RE: Percolation Test Site Plan
16381 Old Frederick Road
Comment Letter dated January 10, 2012

RE: Revised Percolation Test Site Plan
16381 Old Frederick Road

PERCOLATION CERTIFICATION PLAN
OLD FREDERICK ROAD #16381
Mt. Airy, Maryland
Parcel 463
Tax Map 7 Grid 0004
Election District 04-05 Howard County, Maryland

MOUND PLAN VIEW, 1" = 20'

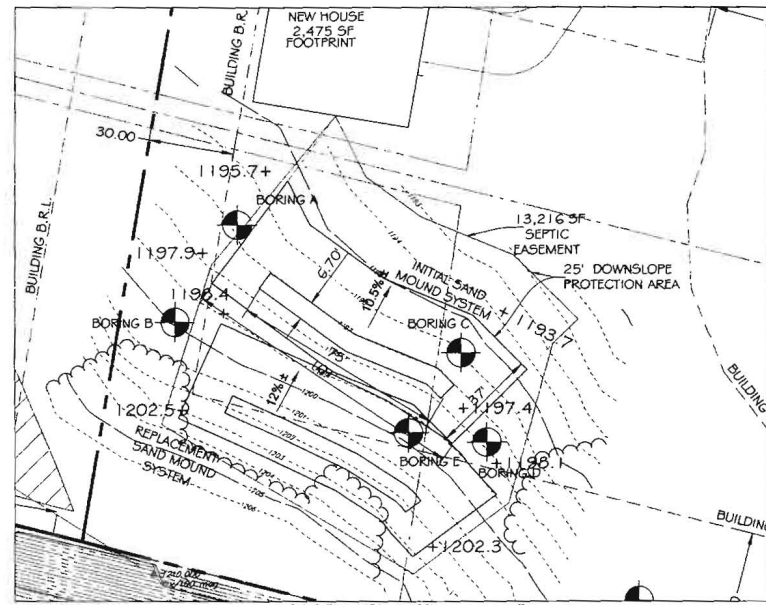
Hello Walter. The original well location for lot 2 is downgradient of the septic area on the neighboring property at 16373 Old Frederick. If you propose a new location, it must stay at least 200' away from that septic area. The new area you proposed might be less than 200' from it, it's hard to tell. You do not have to have a perfectly square well box, you could make it more rectangular in shape to put it on that side of the new driveway while keeping it 1500 sq ft and 10' from the drive as well as at least 200' from the neighboring septic area.

In order to approve the new area, you would have to submit a revised perc cert plan (3 paper copies) for signature. As long as you maintain those setbacks, it should be ok. One other thing I noticed: if you are revising the perc cert, I'd like an additional note added. MDE approved a variance for that well box location subject to the condition that the well be drilled with steel casing extending at least 50' or 10' into bedrock, whichever is deeper. We usually put a note on the perc cert in these cases, but missed putting it on this one. If you revise, please add the following note:

Heidi,
In speaking with the Client, Mr. Keeton, we are considering shifting the well location by 11 feet and flipping the driveway to the east side rather than the west to save some trees. This revision is shown in red on the attached pdf.

We are submitting a revised Percolation Test Site Plan to show a relocated well box on Lot 2. This plans was prepared based on our email correspondence on November 17, 2014. We have added the required note as General Note #4 and added the previously handwritten notes from the previously plan approval as General Notes #5 & 6..

OVERALL PROPERTY PLAN VIEW, 1"=60'

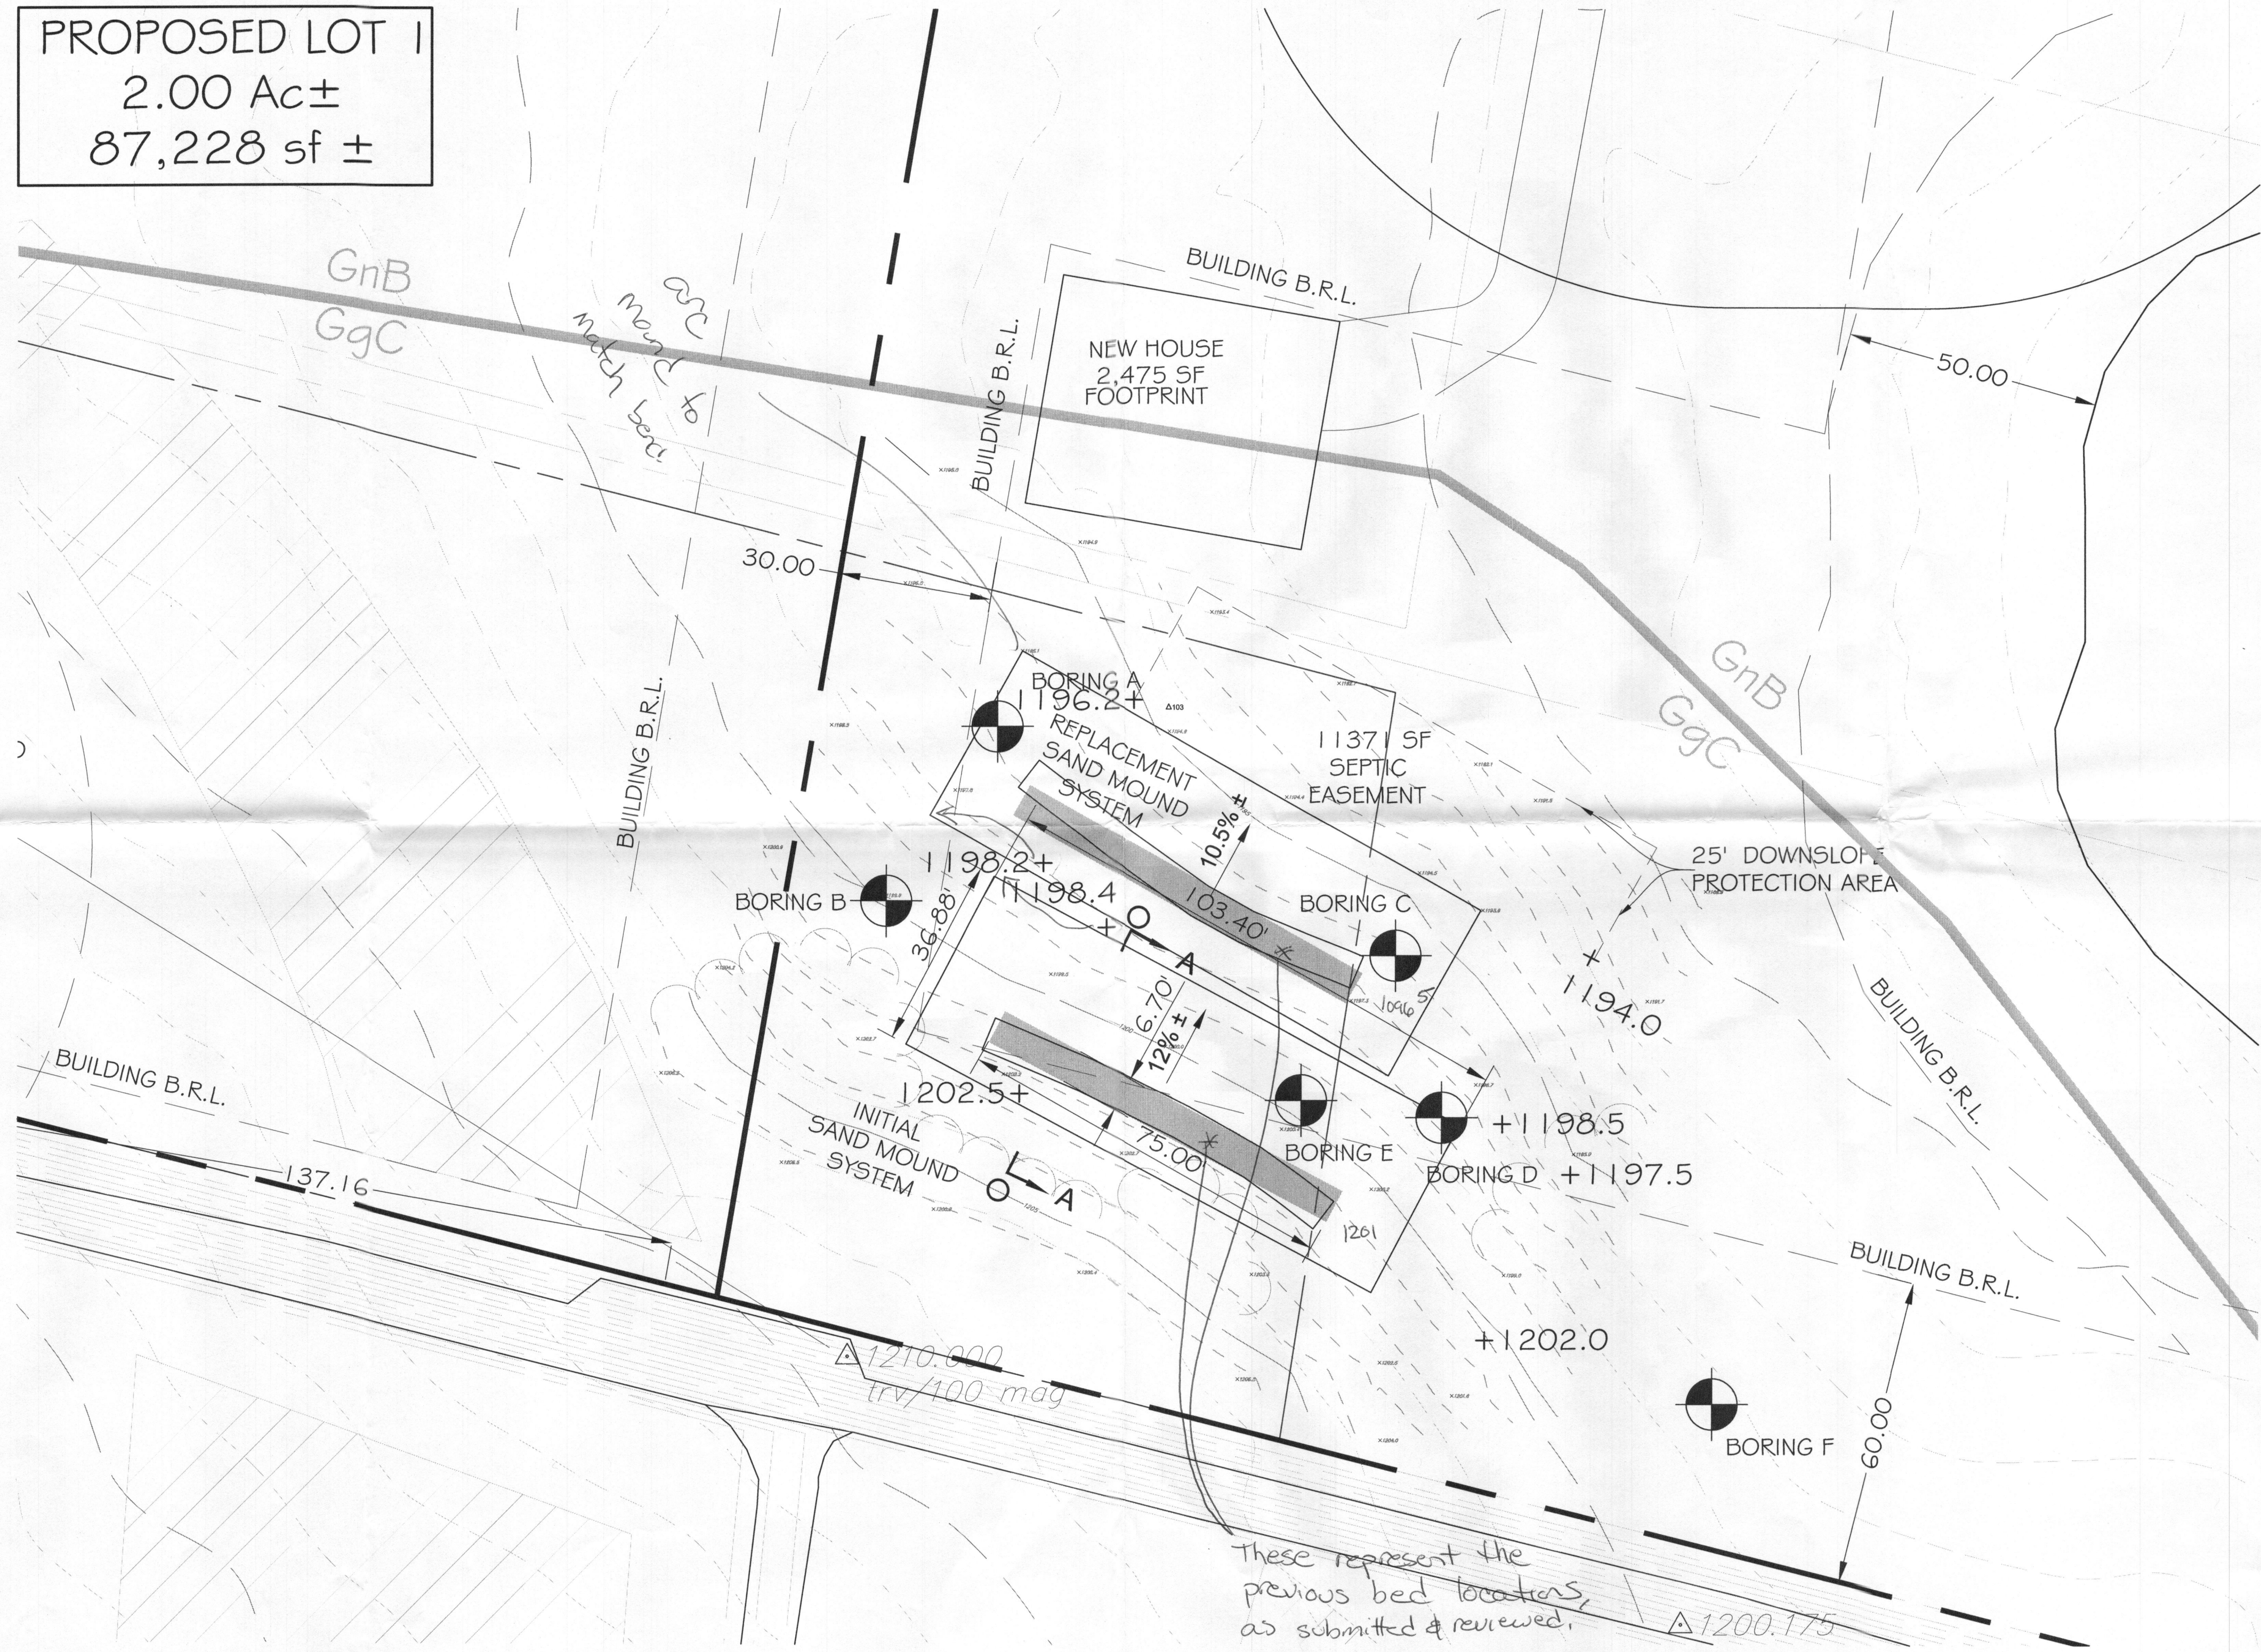
Comment #2: Remove the 1-foot, field surveyed contours from the "Overall Property Plan View".

Comment #3: Add the Septic Hatch area to only the "Overall Property Plan View".

Comment #3: Revise the sheet layout to show the 20 scale plan view as the main plan view and the 60 scale to show the overall property.

Response #2: These have been removed.

Response #3: The Septic area is now only hatched on the "Overall Property Plan View".

Response #3: The plan views have been revised accordingly. The 60 scale has a note associated with it stating the contours are GIS and the 20 scale has a note stating the contours were field surveyed.

MOUND PLAN VIEW, 1"=20'

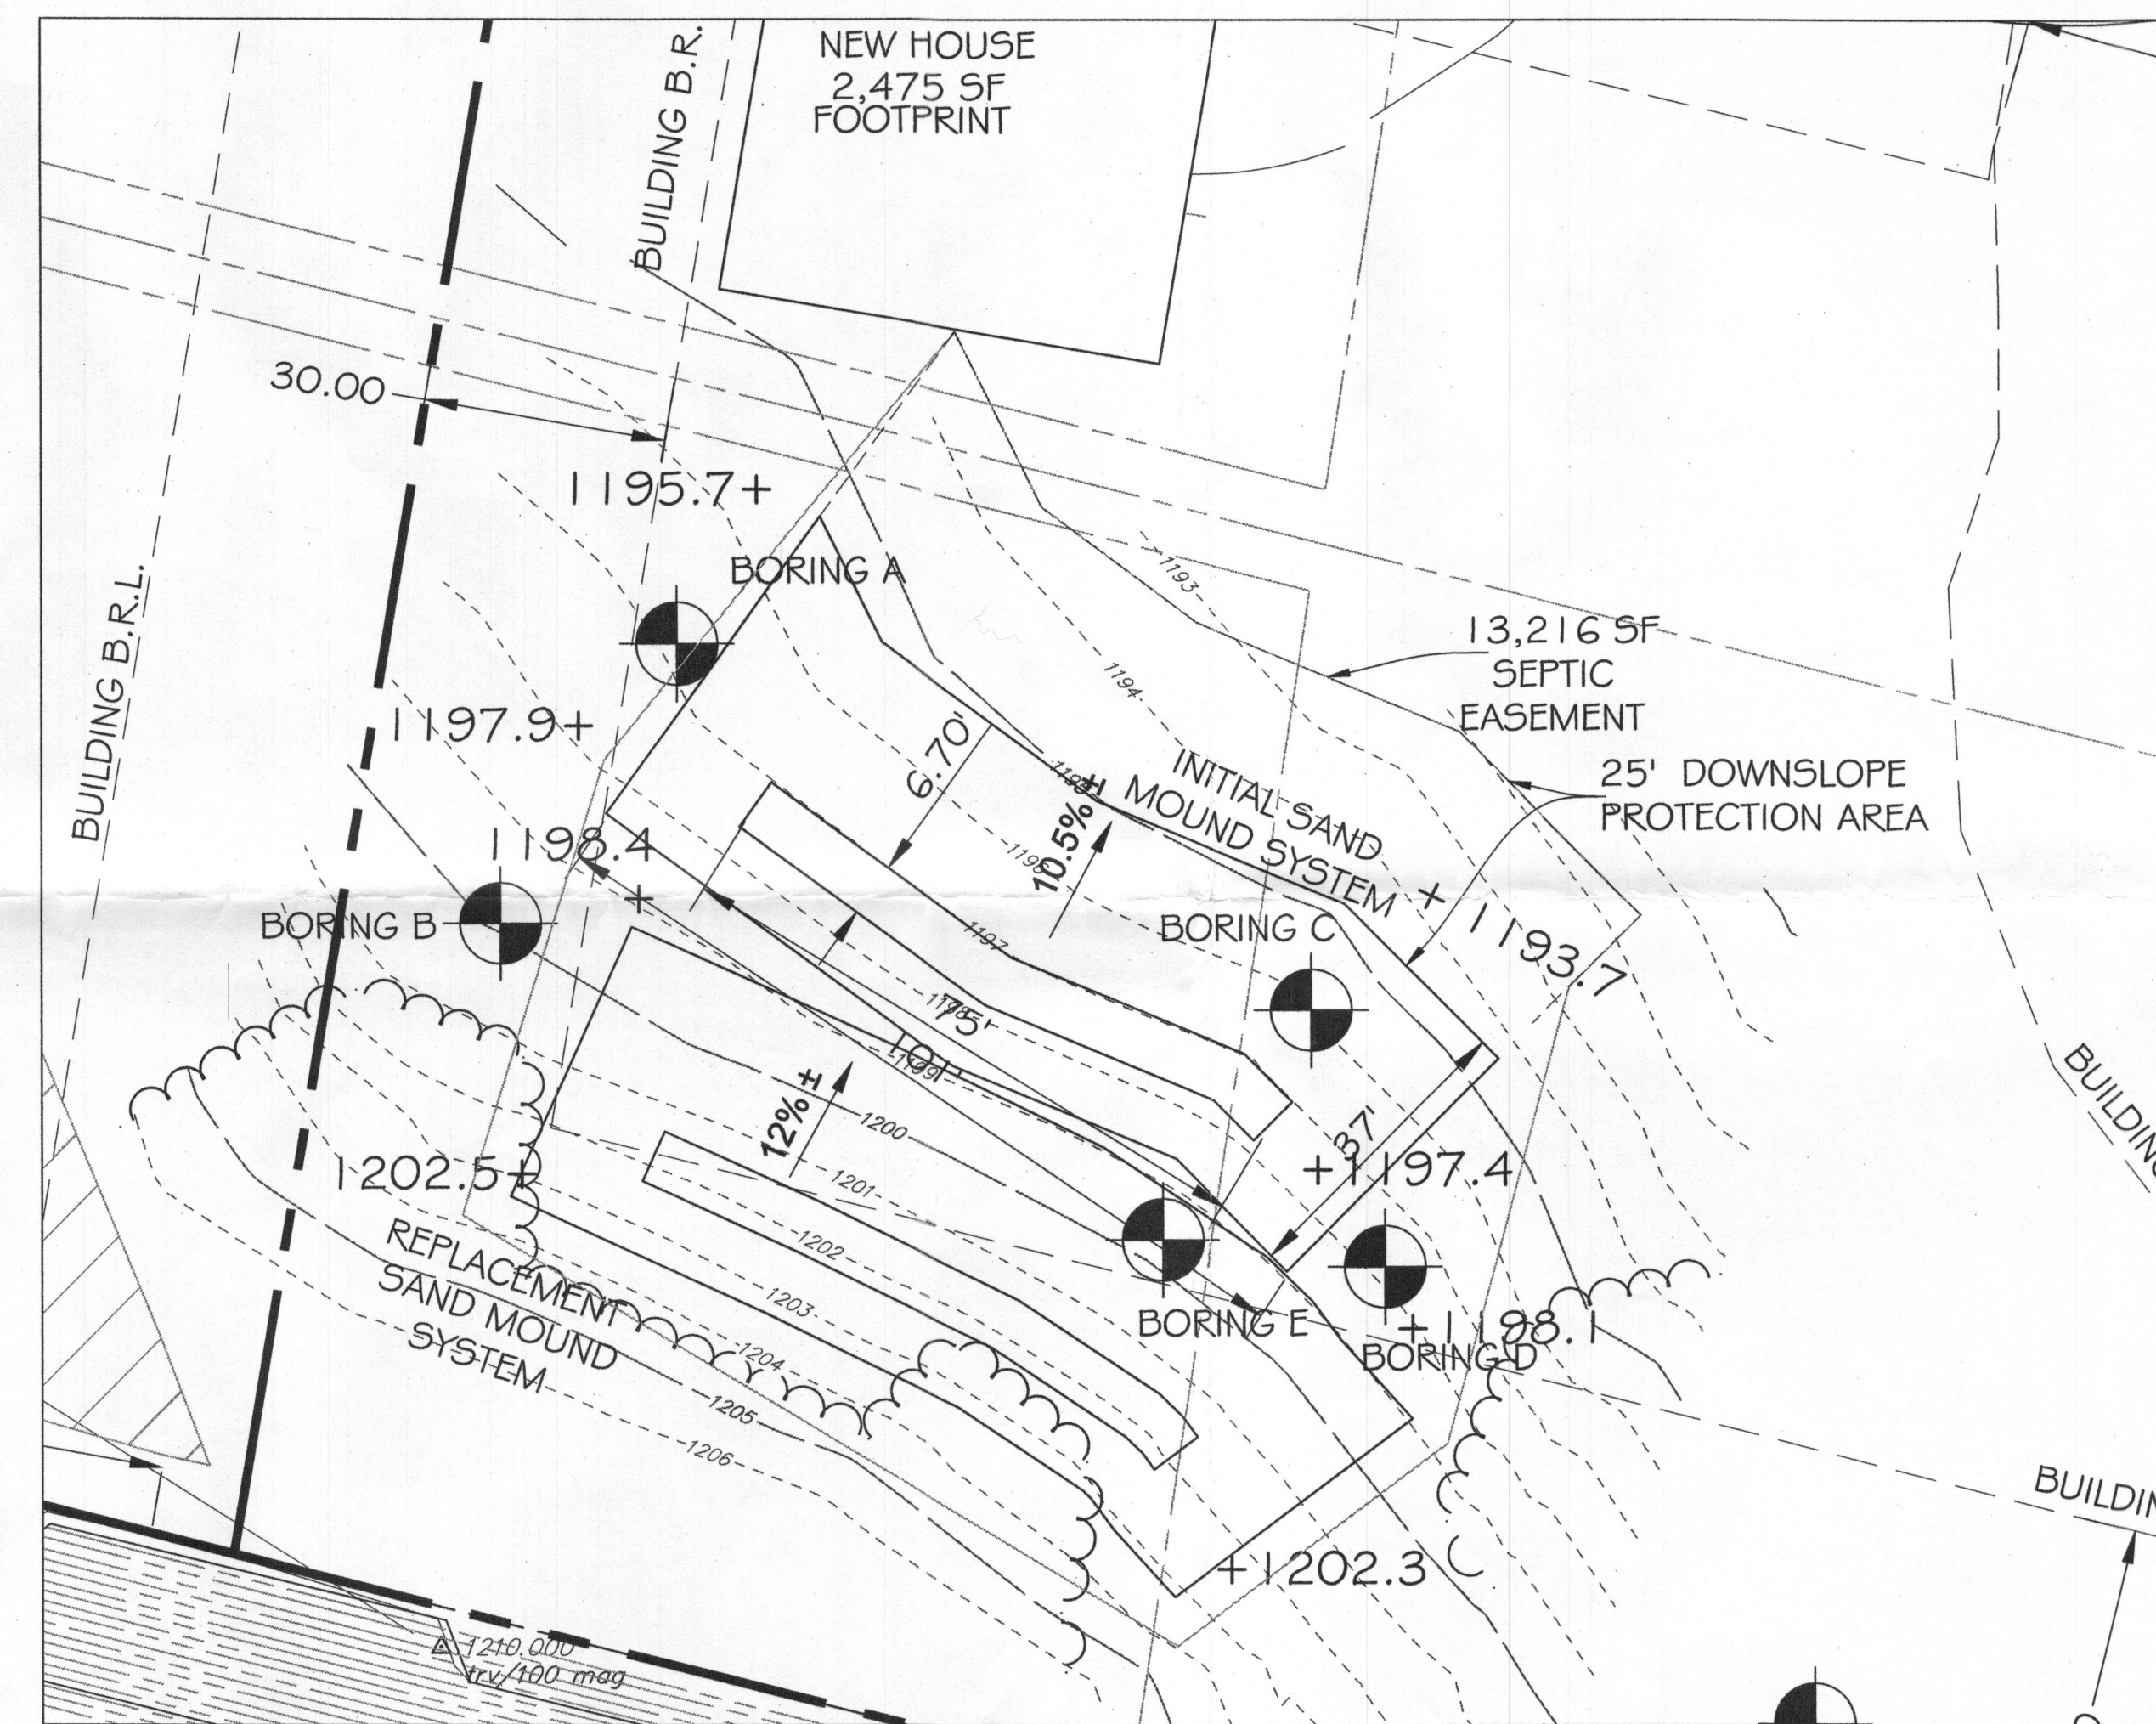
Comment #4: Show all four corner elevations for the mound and bed areas. Corners must be staked in the field for Health Dept. review.

Comment #5: Label the 25' downslope protection area from the edge of the mound closest to the proposed house (see Design and Construction Manual Section 3.2.16).

Comment #1: Remove the GIS contours from the "Mound Plan View".

Comment #1: Revise the beds to run along the contour.

Comment #2: Revise the mounds to run parallel to the beds.

Response #4: The corners of the mound system have been staked. These are noted in the bottom left hand corner of the attached plan. Please note the elevations are based on an assumed datum, based on the field stakeout location by Axiom Engineering, and are relative to each other. They do not correspond to the GIS contours shown on the overall plan view.

Response #5: This protection area has been labeled.

Response #1: These have been removed.

Response #1: The beds have been revised.

Response #2: The mounds have been revised.

4-24-12
marked plan from
mtg w/ Heidi Scott

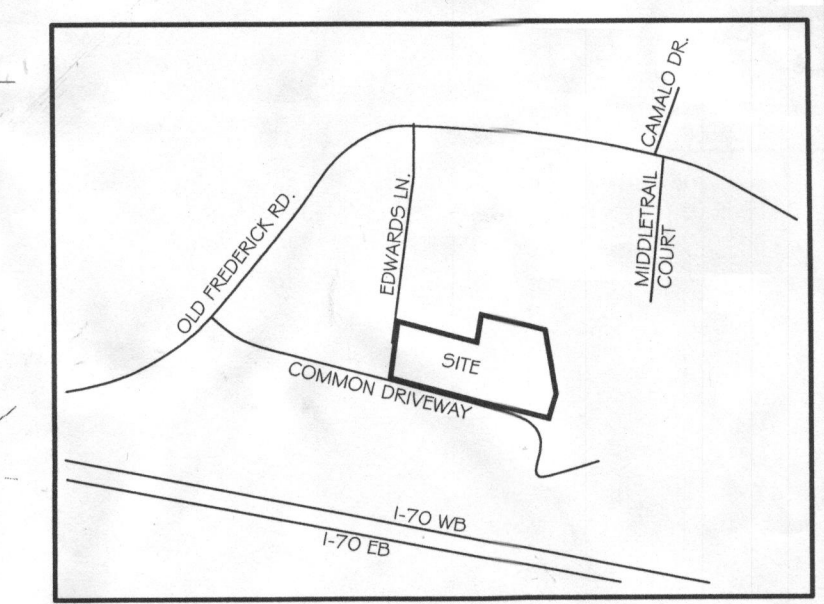
- ✓ 1) Extra contour layer?
- ✓ 2) All 4 Corners of the sand mounds & All 4 " of the beds. need to be staked out by LLS w/ corner elevations shown, on the field stakes.
- ✓ 3) Construct upper sm 1st
- ✓ 4) Eliminate D box? What is other square?
- ✓ 5) Designate the 25' ~~prot~~ downslope protected area

Comment #5: Revise the mound systems per the Health Department mark-up provided in our meeting.

Response #5: These have been revised as requested.
